**IMPERIAL METALS CORPORATION
MT. POLLEY PROJECT**

**RESPONSE TO REVIEW COMMENTS
ON TAILINGS EMBANKMENT DESIGN
(REF. NO. 1625/6)**

JANUARY 25, 1996

IMPERIAL METALS CORPORATION
MT. POLLEY PROJECT
TAILINGS STORAGE FACILITY
MATERIAL SPECIFICATIONS

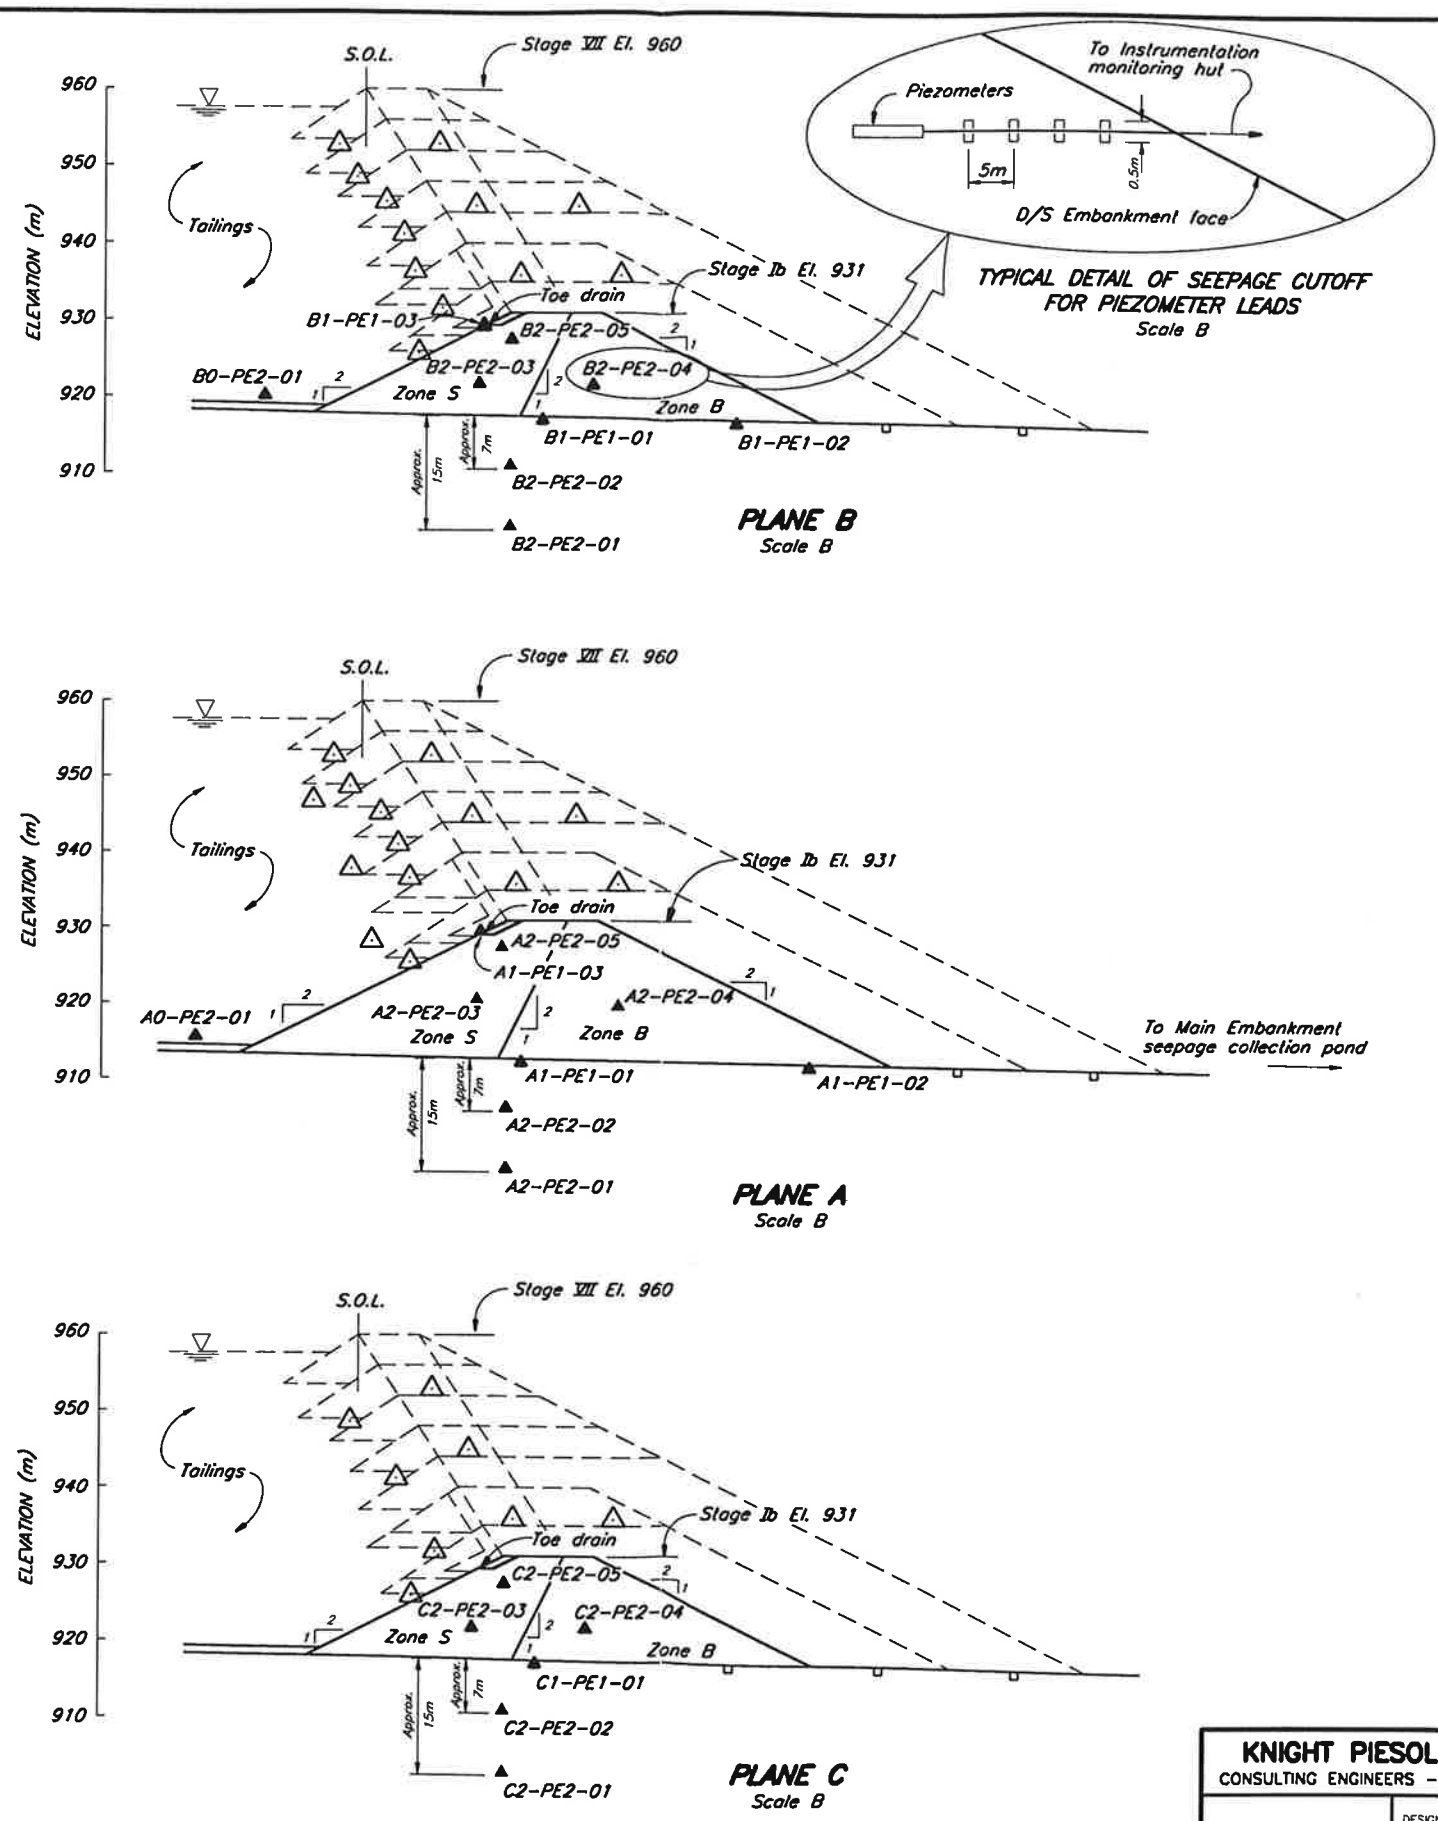
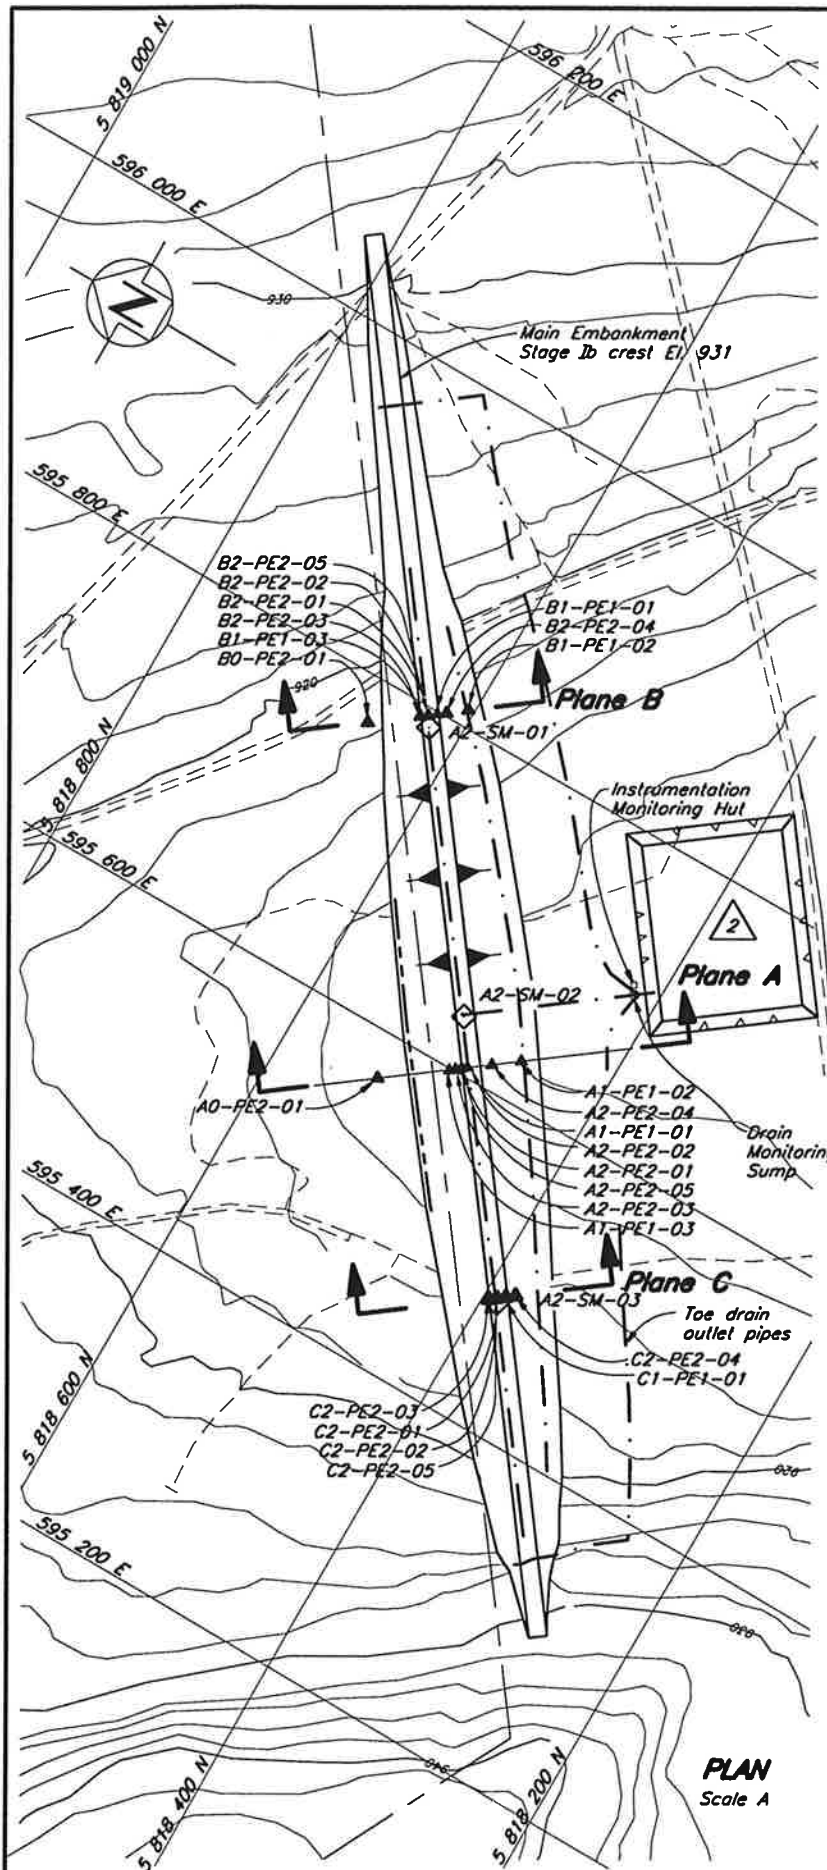
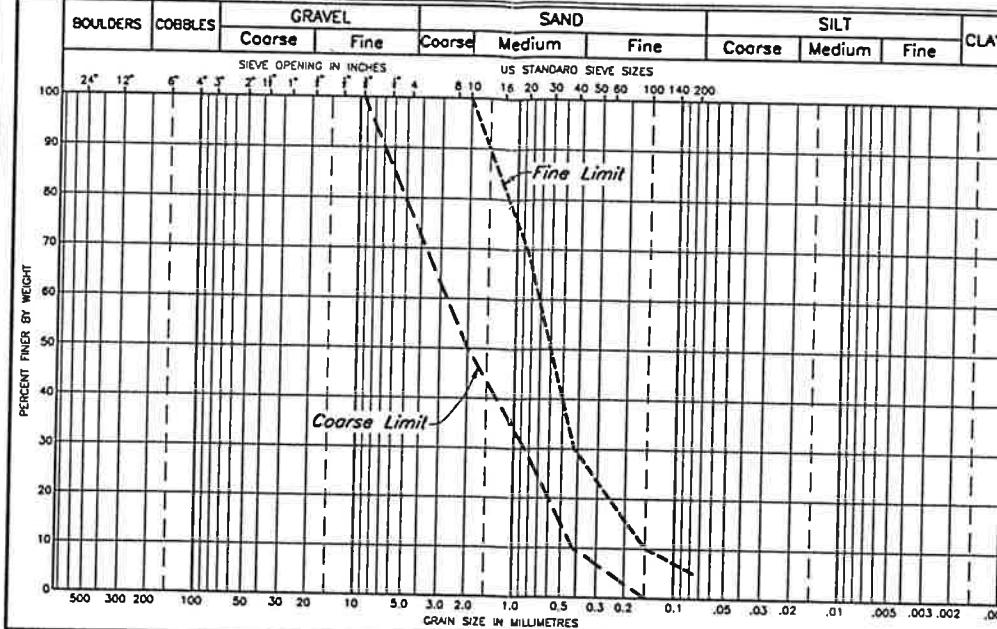
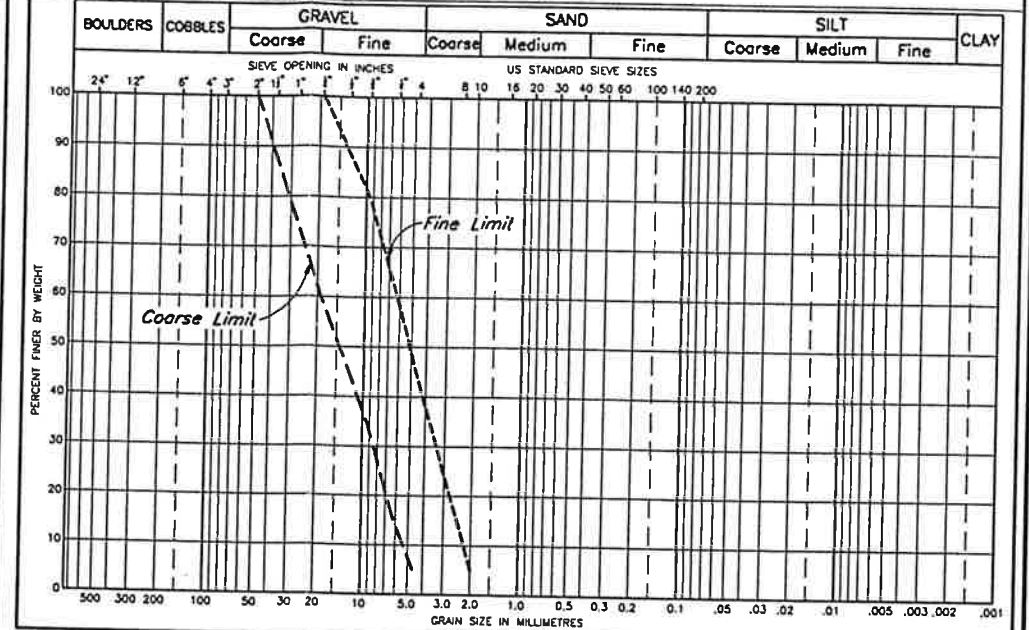
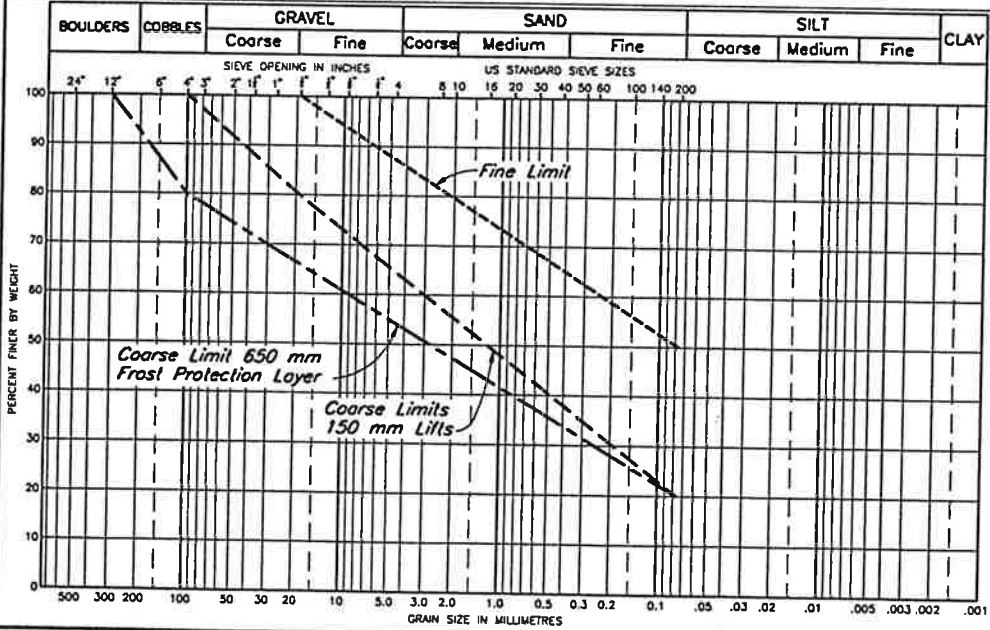
Filter gradation is required to be shown. The design must be conservative.

Provide the range of acceptable gradation.

Filter gradations for construction materials are shown on Drawing No. 510-14-03-1625.212, which is taken from part of the Technical Specifications. The gradation of the tailings is shown on Figure 1 (from Tailings Storage Facility Design Report, Ref. No. 1625/1, May 26, 1995).

Gradation envelopes for embankment fill materials are also included on Drawing No. 510-14-03-1625.212.

DATE **JUNE 2, 1995** SCALE AS SHOWN DRG. NO. **510-77-01-1625.220** REV. **2**

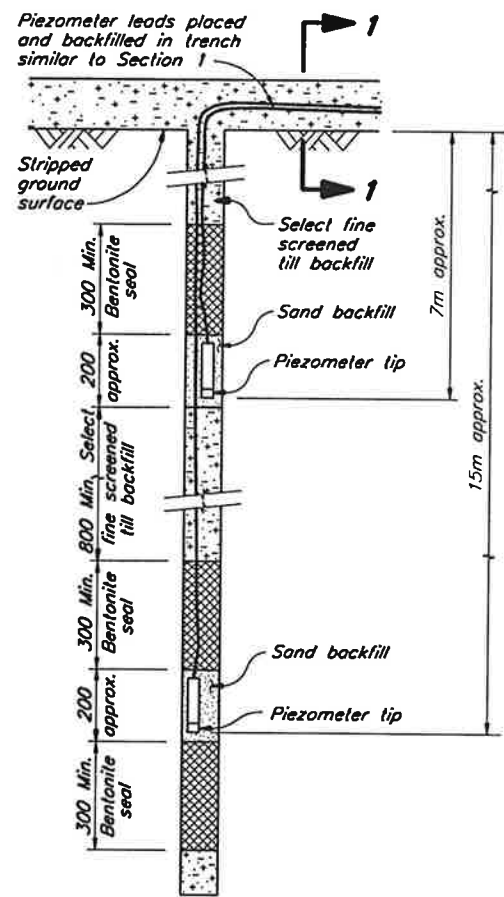
Only one drill hole appears to have been drilled in the main embankment area. In B.C. valleys there is always the possibility of buried high permeability zones. It is recommended that 2 more boreholes to expand the geotechnical information be drilled and tested.

One hole has been drilled in the Main Embankment area (MP89-234), as noted by Mr. Brawner. It has previously been discussed with Mr. Headley (MEMPR) and it was agreed that three additional holes will be drilled, logged and sampled by a geotechnical engineer during the initial stages of construction as part of the embankment instrumentation and monitoring requirements. The holes are specified in

the Technical Specifications and shown on Drawing Nos. 510-77-01-1625.220 and 1625.221. They will be drilled to about 15m depth and will be located in the bottom of the main valley, where significant overburden is known to be present. Lab testing will be conducted on the samples as required and vibrating wire piezometers will be installed in the embankment foundation for long term water pressure monitoring.
